ALERT SERVICE BULLETIN

412RSAF-24-53

MODEL AFFECTED: 412RSAF

SUBJECT: CAP ANGLE, P/N 212-030-191-001, INSPECTION INTERVAL, REDUCTION OF.

Figure1. Fuselage Tailboom Attachment Inspection.

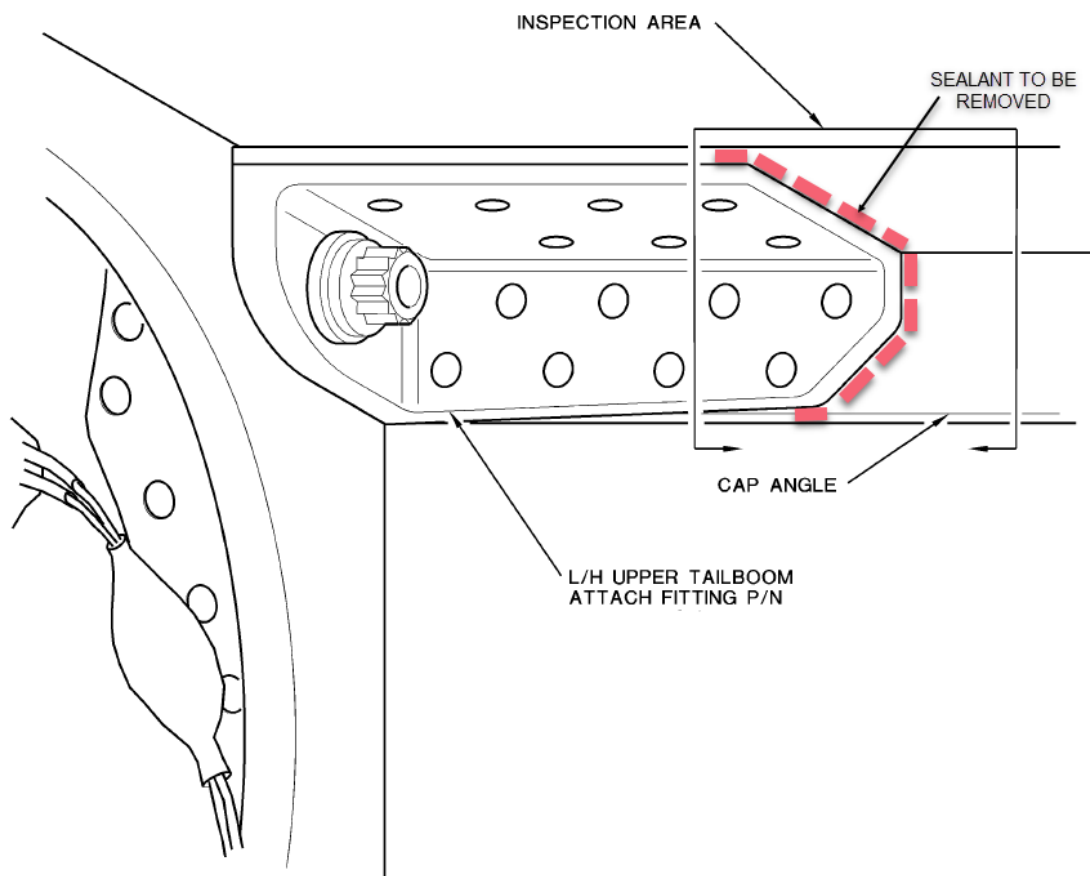
2. If sealant is present, remove sealant from edge of fitting (Figure 1).
3. Inspect the cap angle area shown with a 10x magnifying glass and bright light.
4. If a crack is found, replace the cap angle before further flight. If the helicopter is at a location where the cap angle cannot be replaced, contact Product Support Engineering.
5. Touch up primer if damaged during sealant removal. Paint touch up is optional. Do not reapply sealant.
6. If no cracks are found, the helicopter can be returned to service.
7. Make an entry in the helicopter logbook and historical service records indicating findings and compliance with this Alert Service Bulletin.
